| Project Title: | Carlsbad Energy Center - Compliance |
| Document Title: | Project Owner's Responses to Data Requests in Set One (Nos. 1-30) |

Re: Carlsbad Energy Center Project Petition to Amend (07-AFC-06C)
Project Owner's Responses to Data Requests in Set One (Nos. 1 - 30)

Data Response Set 1 (Responses to Data Requests 1 to 30)

EA138-E-30

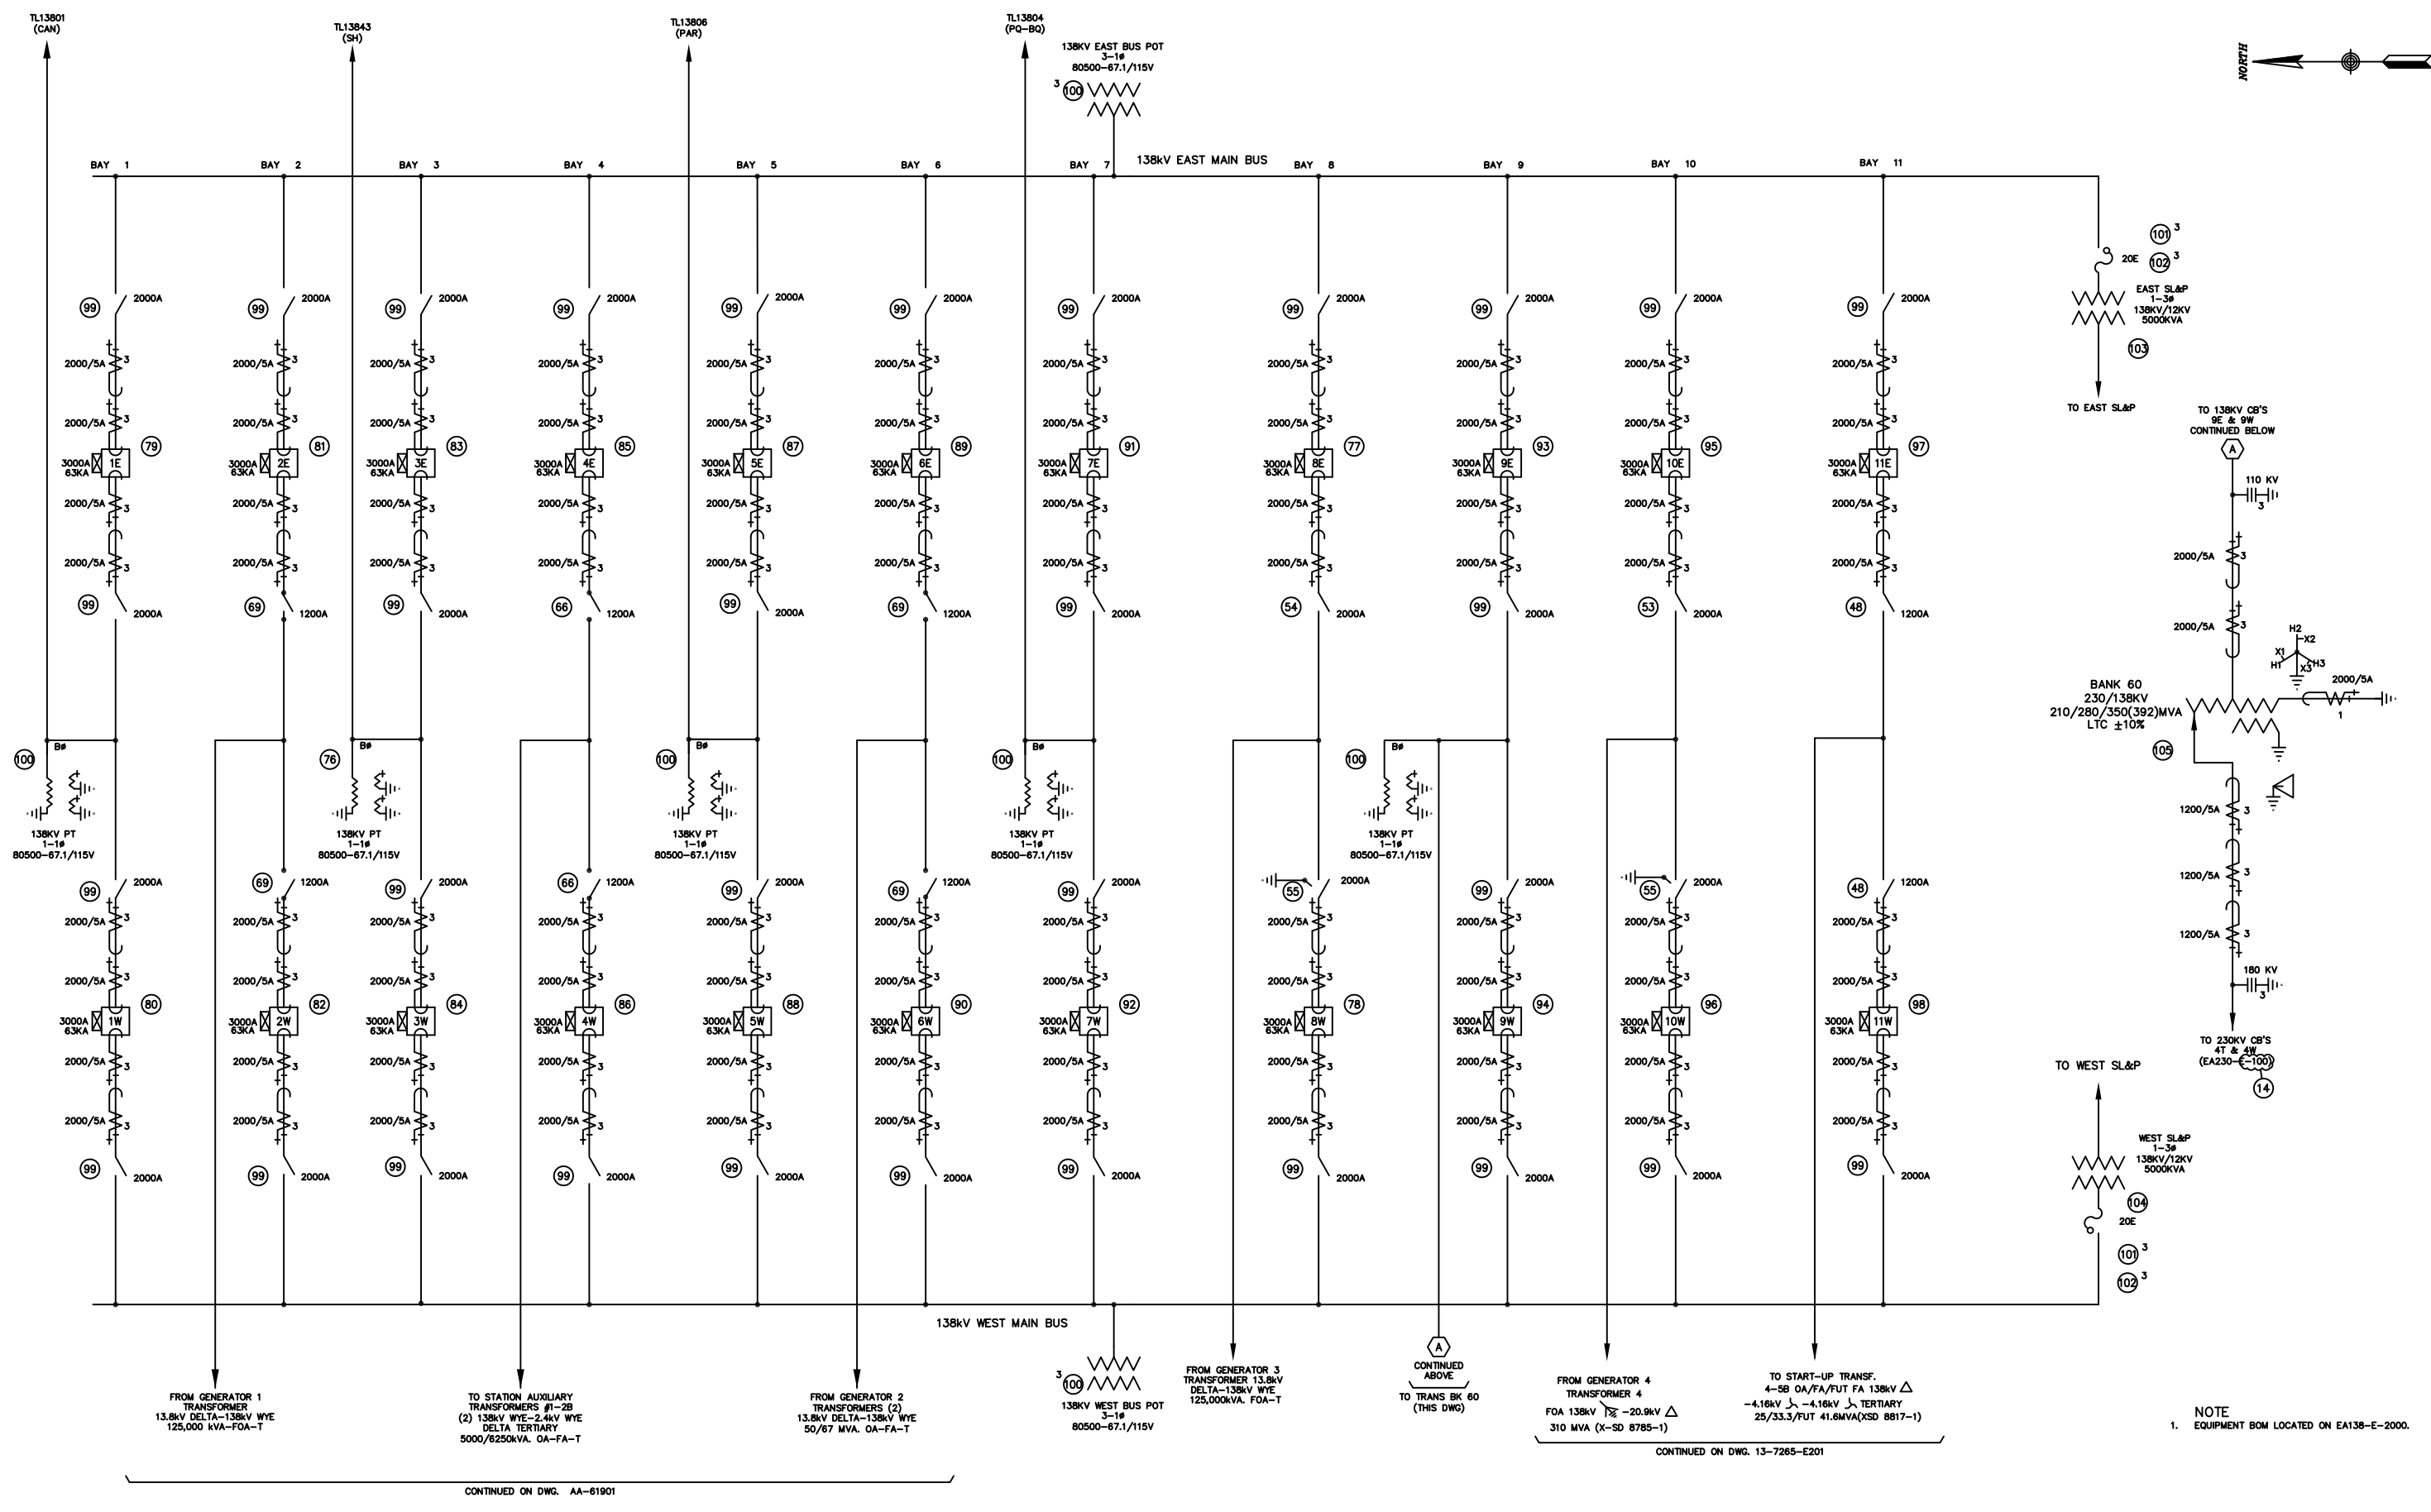
28. Submit pre and post-project electrical one-line diagrams of the existing SDG&E EPS 138 kV and 230 kV switchyards showing configuration of switchyard buses and switching bays (with SB nos.) with breakers and associated disconnect switches with their respective sizes and/or ratings in amperes along with all transmission outlets showing the modifications in the switchyard for interconnection of the overhead 138 kV and the UG 230 kV gen tie lines. In addition, provide post-project electrical one-line diagrams of the SDG&E 138 kV and 230 kV switchyards after the decommissioning of the Encina Power Station (EPS), and disconnection of the existing EPS Units as scheduled in 2017. Fully describe and detail any and all measures proposed to insure transmission infrastructure integrity and the during the EPS demolition activities sought by the in the PTA. Moreover, describe any and all transmission measures and details planned for the seamless and timely transition from EPS Unit electrical generation to that of the Amended CECP.

Response: Electrical one line drawings of the existing SDG&E EPS 138 kV and 230 kV switchyards are included below as Figures DR28-1 and DR28-2, respectively. Project Owner has requested the post-project electrical one line drawings from SDGE and will furnish them to the CEC upon receipt from SDG&E. As these drawings may not arrive until mid-September, Project Owner requested additional time to provide them in Project Owner's objections and time extension request letter to the Commission dated August 5, 2014.
